ADDENDUM NO. 1
November 3, 2020

- A. Brooks Stadium East Gates, H17-N123-MJ
Coastal Carolina University, Conway, SC

CCU BROOKS STADIUM EAST GATES CONWAY, SC

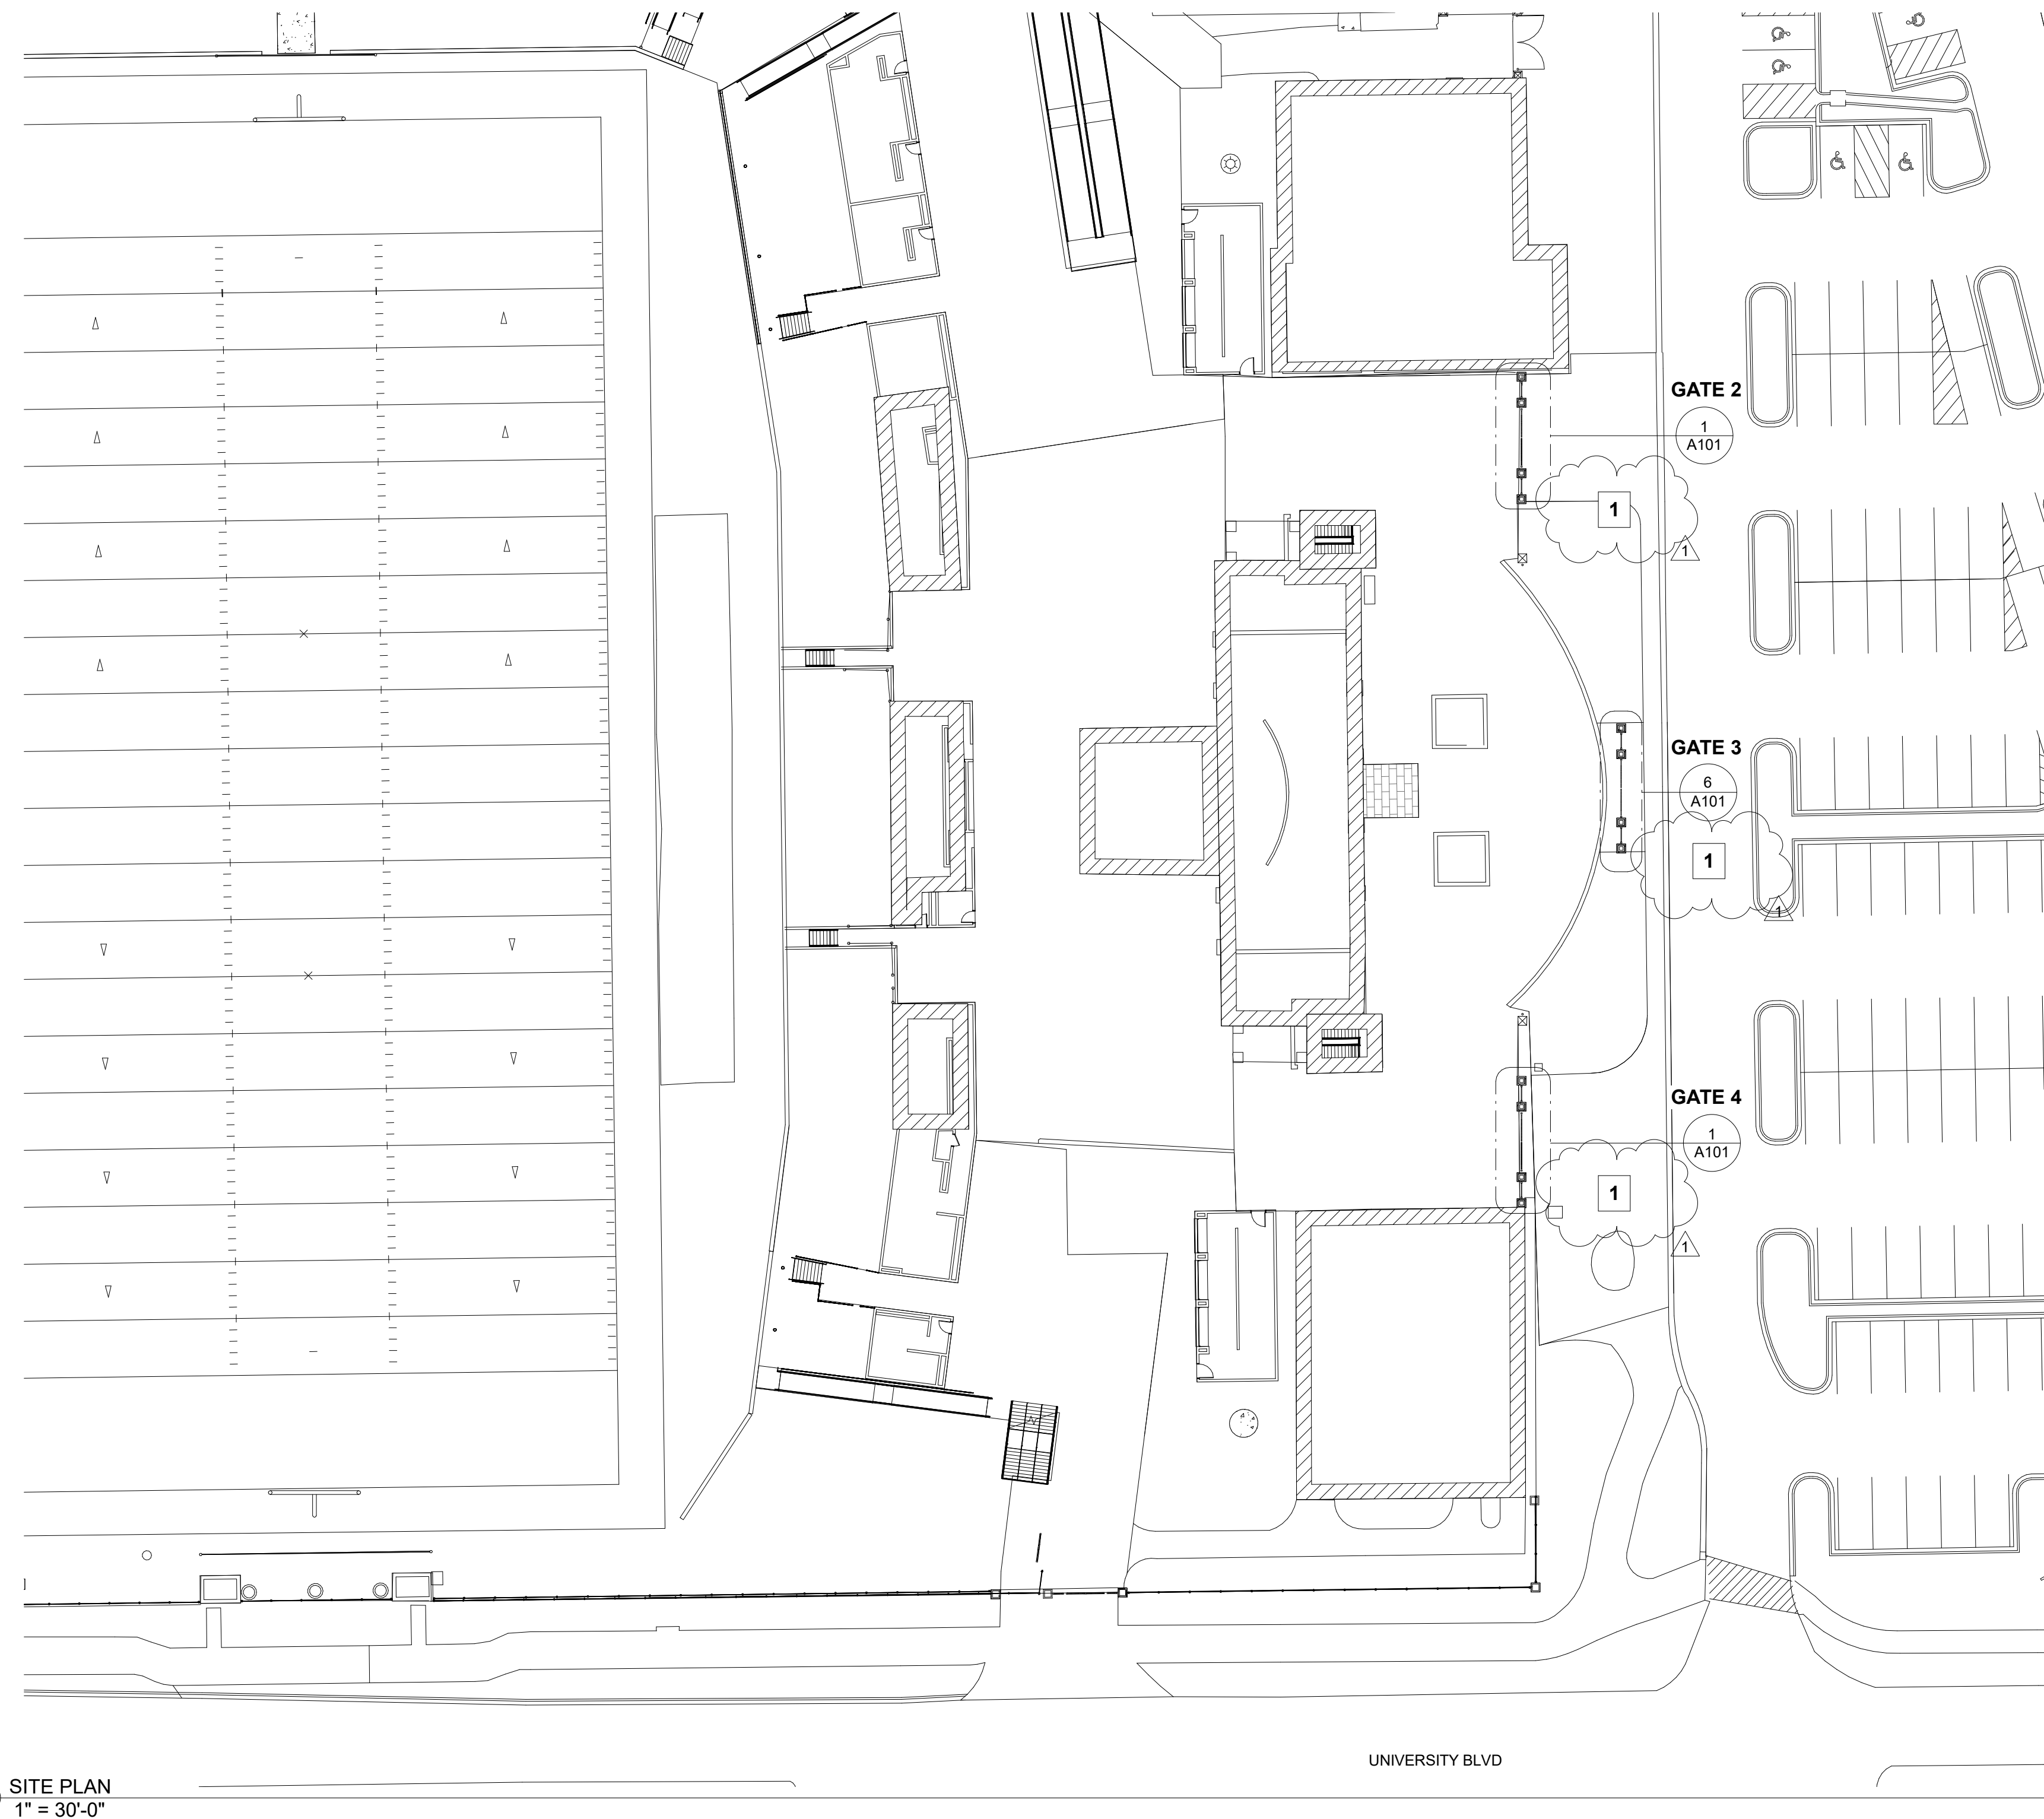
A. Sheet A000. Replace sheet with revised sheet A000 with 10/28/2020 revision date. A summary of revisions is as follows:

1. Added Gate Numbers for clarification
2. Added Construction Note 1, temporary fencing requirements.

- 1 PROVIDE 6' TALL CHAIN LINK CONSTRUCTION FENCING AT EACH GATE AS REQUIRED TO SECURE ACCESS TO STADIUM AND PROTECT AREA OF WORK.

A101

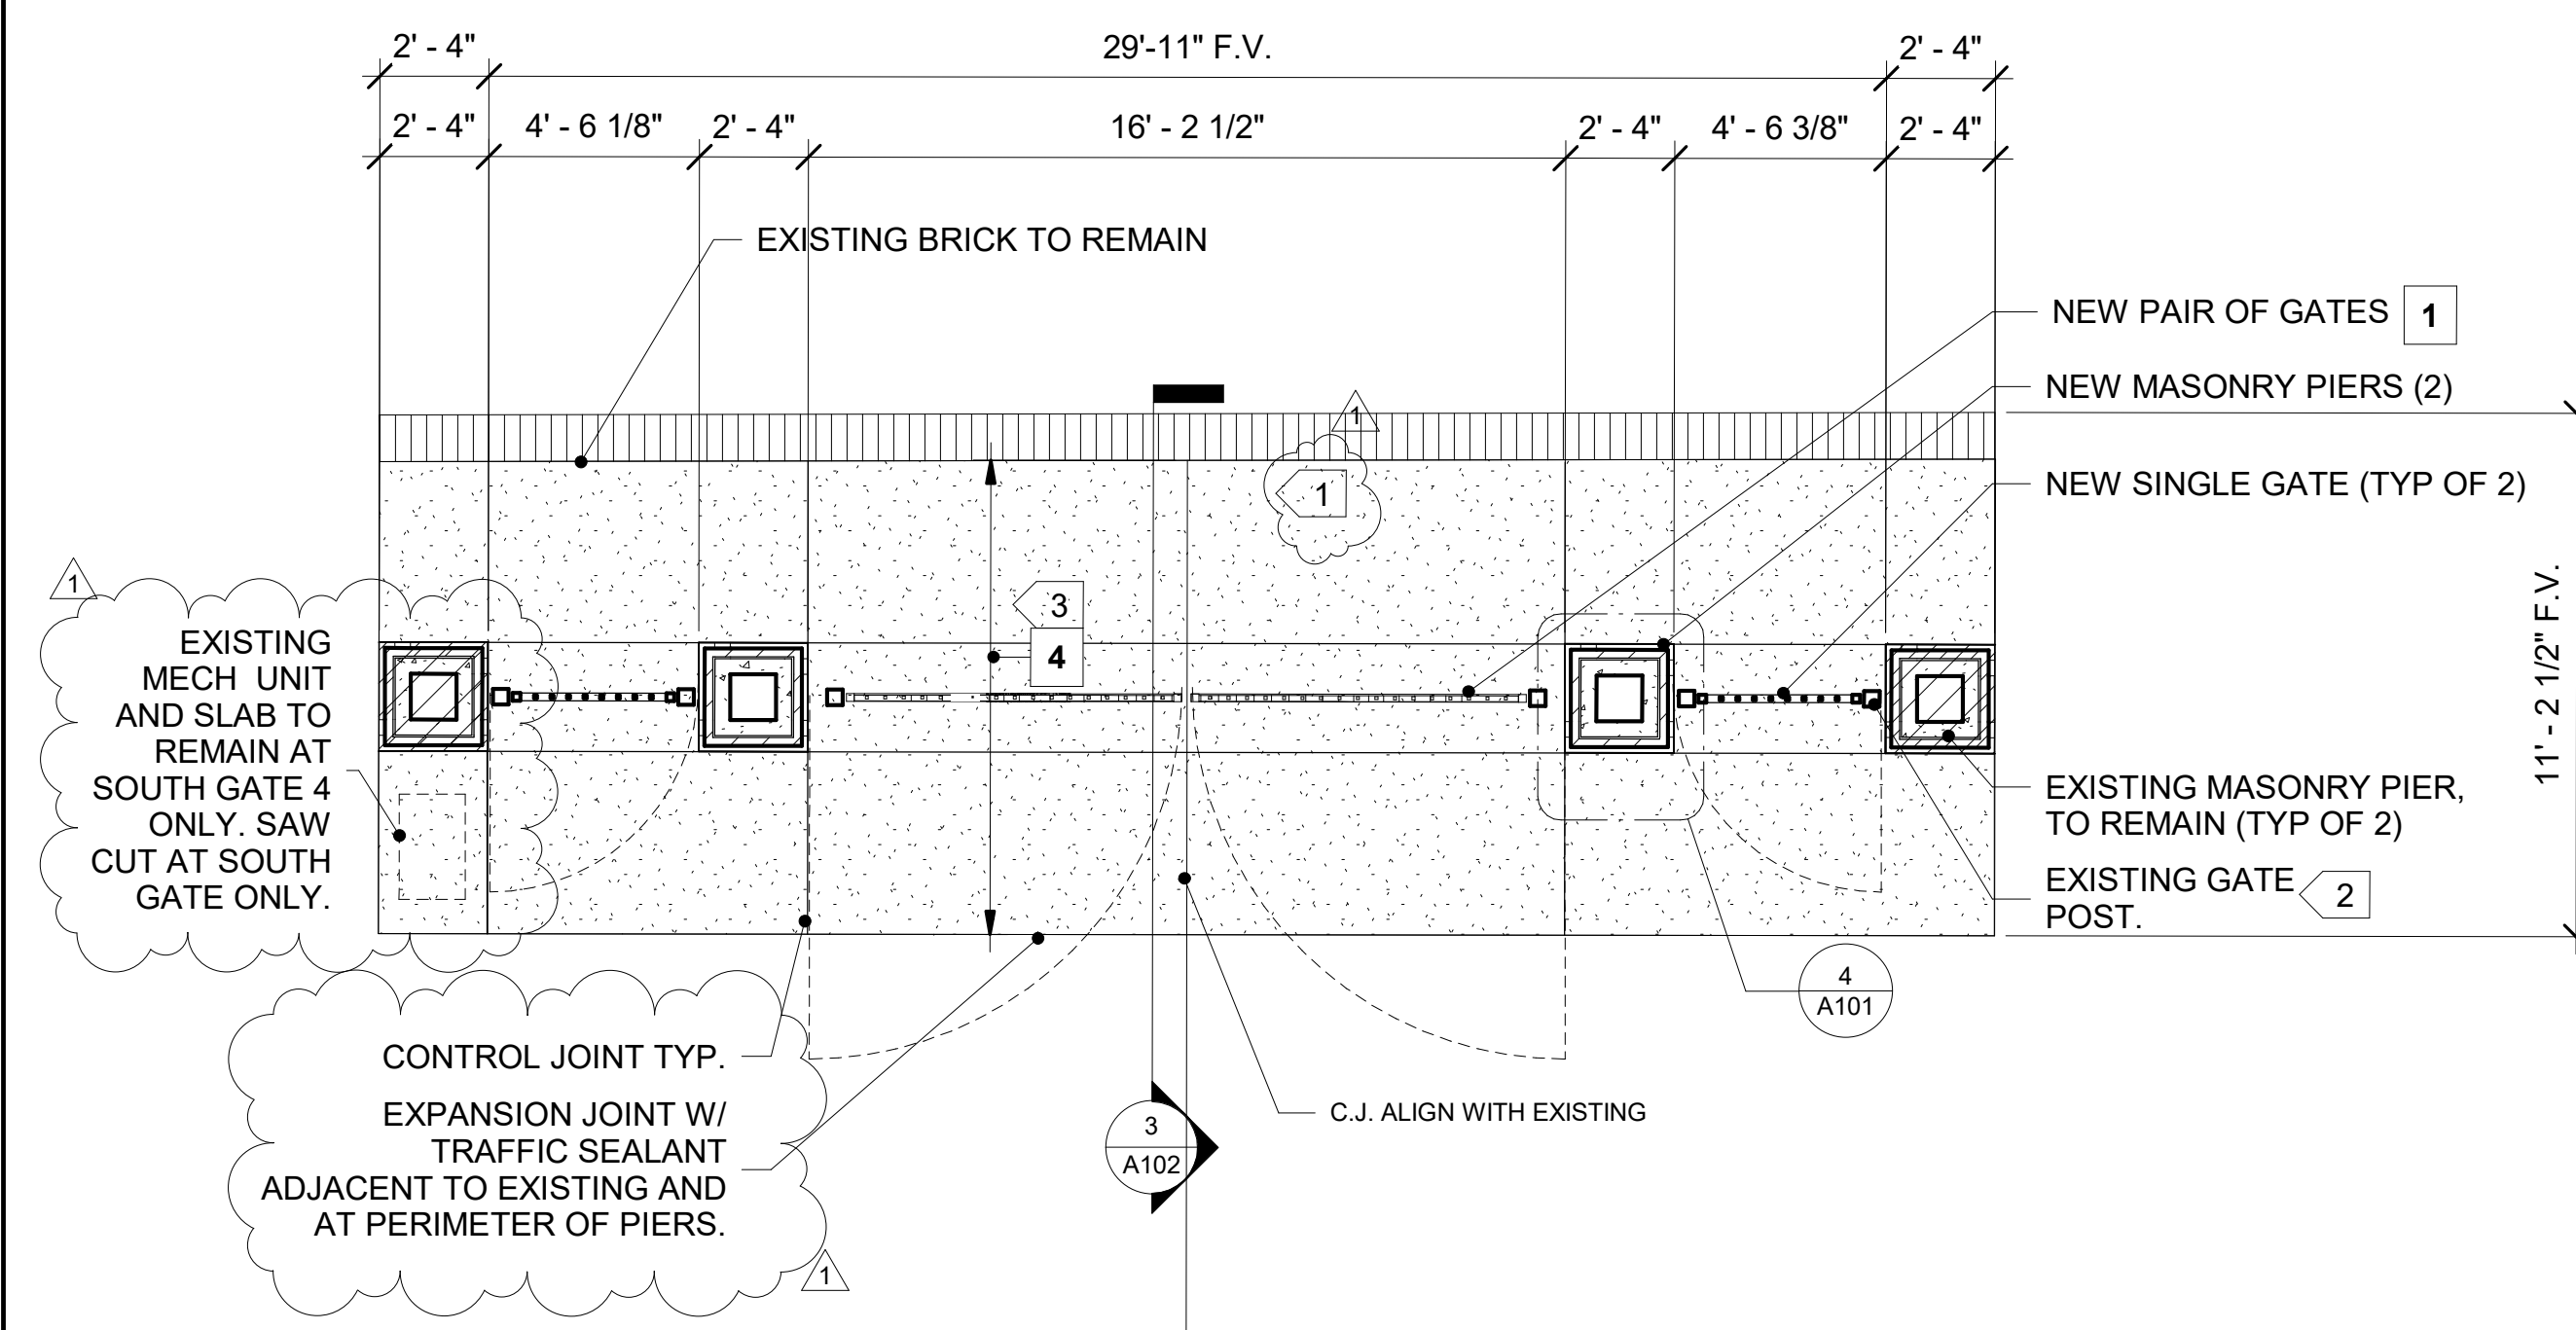
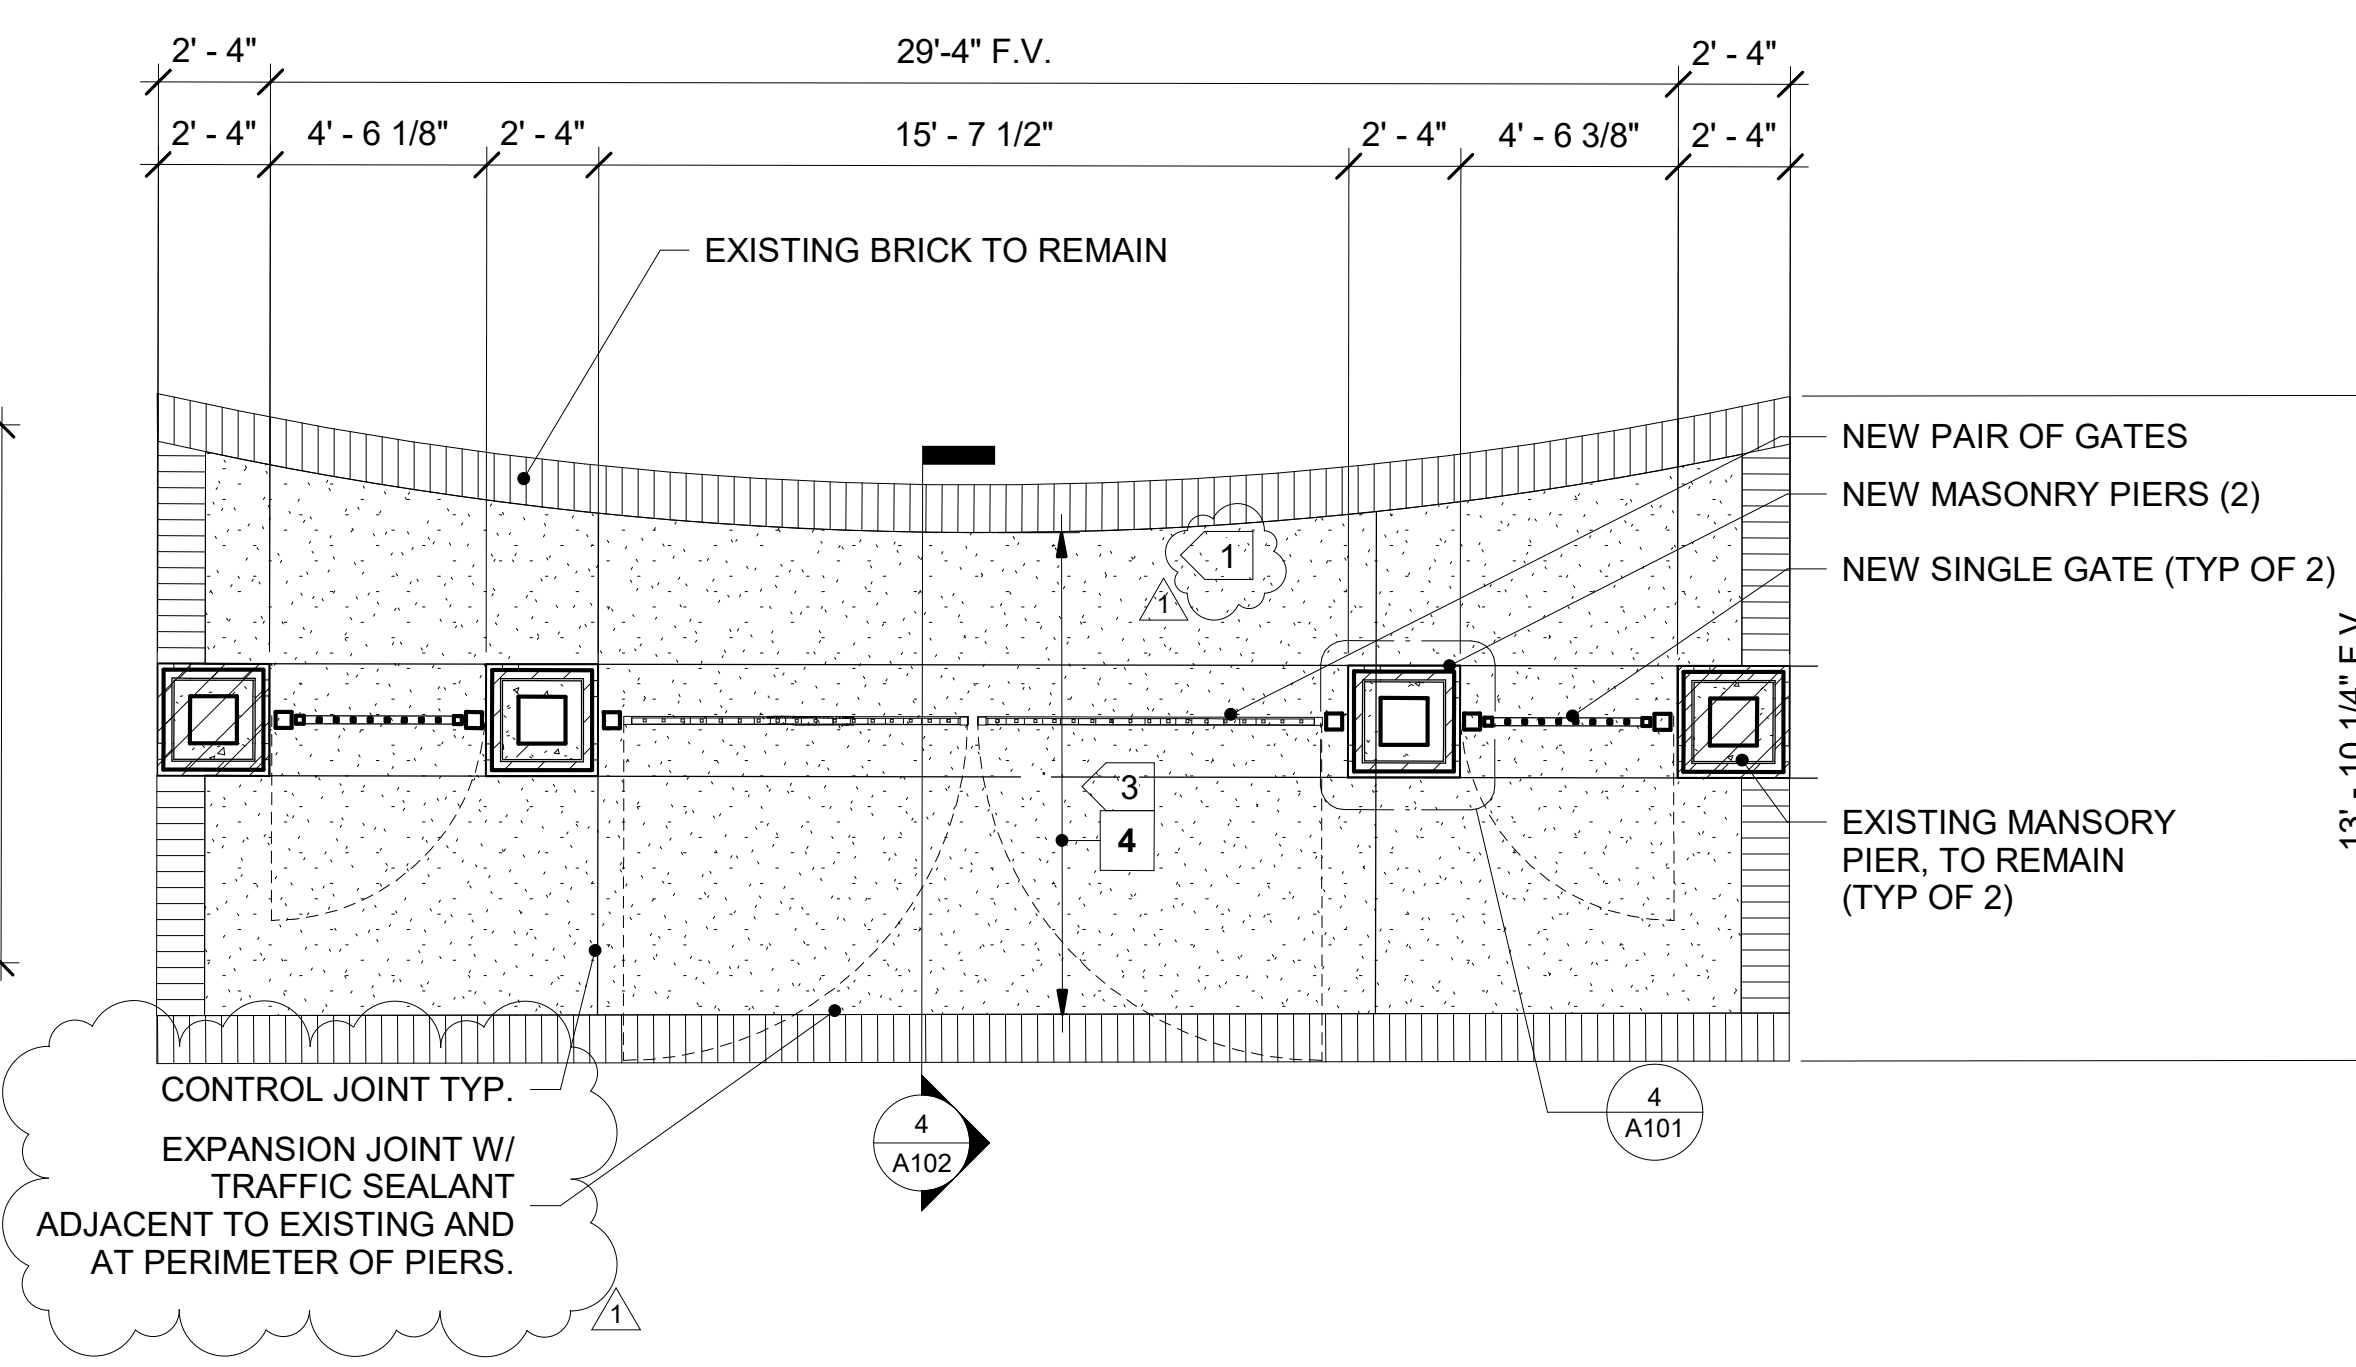
B. Sheet A101. Replace sheet with revised sheet A101 with 10/28/2020 revision date. A summary of revisions is as follows:

1. Clarified Gate Numbers on details.
2. Clarified extent of pavement and gate demolition.
3. Clarified extent of new concrete slab, control joints, and expansion joints.
4. Clarified logo requirements on gates and added detail.
5. Added signage and lettering requirements for each gate.
6. Deleted requirement for galvanizing steel fabrication.

- 1. NEW FENCE/GATE CONSTRUCTION TO MATCH EXISTING. PROVIDE ALL HARDWARE AND ACCESSORIES FOR COMPLETE INSTALLATION, MATCH EXISTING TYP. FOR ALL NEW GATES.
- 2. GATE LOGO TO BE SOLID MTL. PLAQUE WITH ATHLETIC DEPARTMENT CHANTICLER LOGO ATTACHED - BOTH SIDES OF FENCE. THIS PHOTO IS FOR REFERENCE OF STYLE ONLY. CONTRACTOR TO SUBMIT PROOF FOR OWNER/ARCHITECT APPROVAL.
- 3. INTERNALLY ILLUMINATED 16" CHANNEL LETTERS "BOOK ANTIQUA" FOTN.
- 4. 6" REINFORCED CONCRETE SLAB W/ 6X6XW2.9XW2.9 2" FROM BOTTOM SLAB.

- 1. REMOVE ALL EXISTING FENCING AND GATES BETWEEN EXISTING PIERS.
- 2. GATE POSTS AT EXISTING PIERS MAY REMAIN AND BE REUSED AT CONTRACTORS OPTION. REPAINT TO MATCH NEW WORK.
- 3. CUT AND REMOVE EXISTING CONCRETE SLAB BETWEEN WITH EXISTING CONTROL JOINTS AND BRICK PAVERS. REPLACE WITH NEW SLAB.
